St Leonards South DA Review

Areas 18, 19, 20

30 January 2023

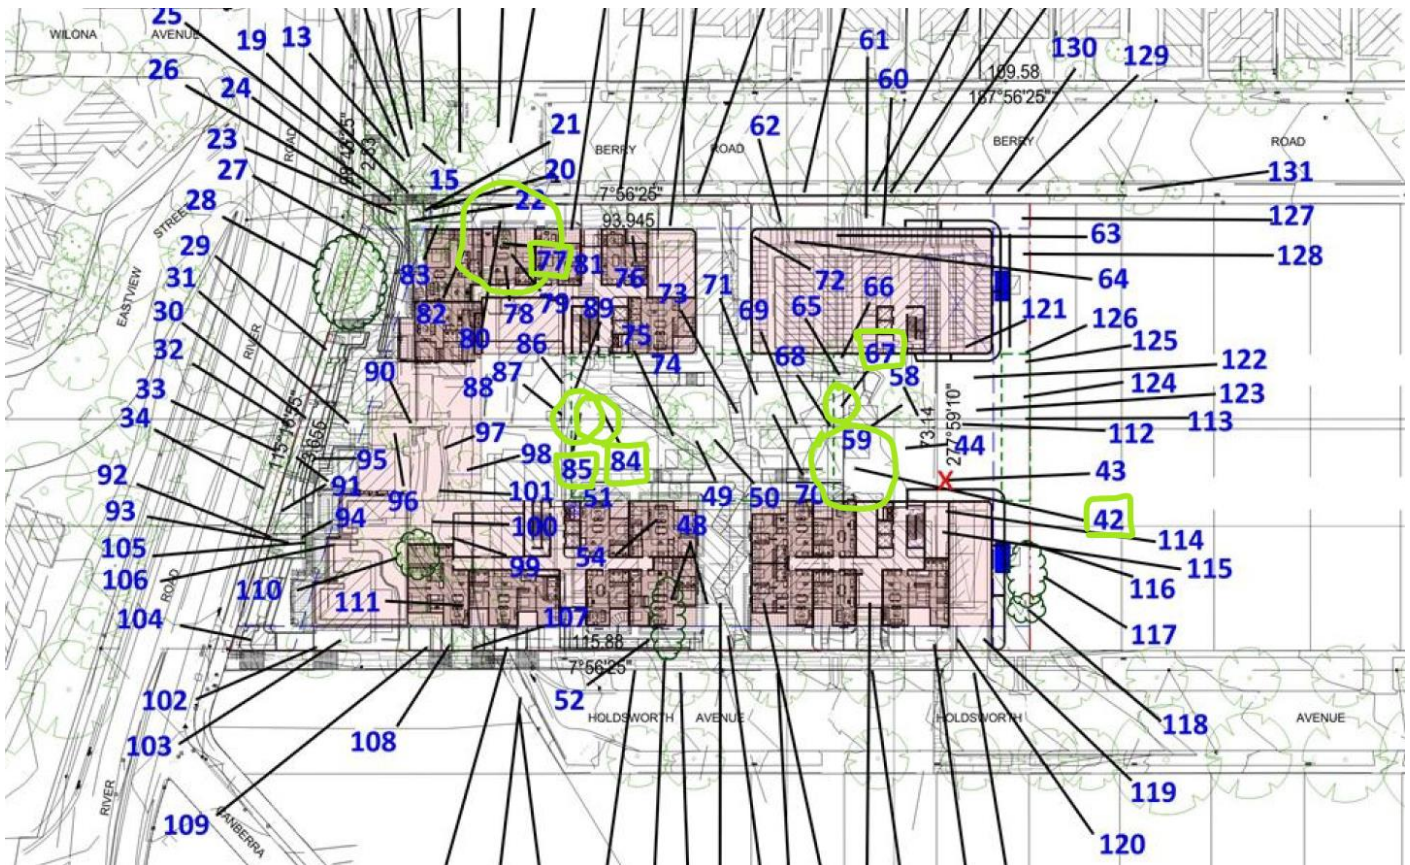
There is significant retaining shown along the eastern, southern and western street interfaces, particularly in the southern half of the site where the existing topography drops away. While these interfaces are shown to be heavily planted, it is critical that the built reality of the planting along these interfaces balances out the visual mass of retaining walls.

Ensure there is a minimum of 1m width planting at the boundary level at the same grade as the boundary to provide screen planting at the base of any retaining walls.

Confirm all retaining walls will have a sandstone finish as represented in the renders and elevations.

Ensure there is sufficient soil area and depth within the raised terraces to support the tree sizes nominated, as well as a layered planting approach. Demonstrate these principles through a section(s) between Building D and the Holdsworth Ave pocket park.
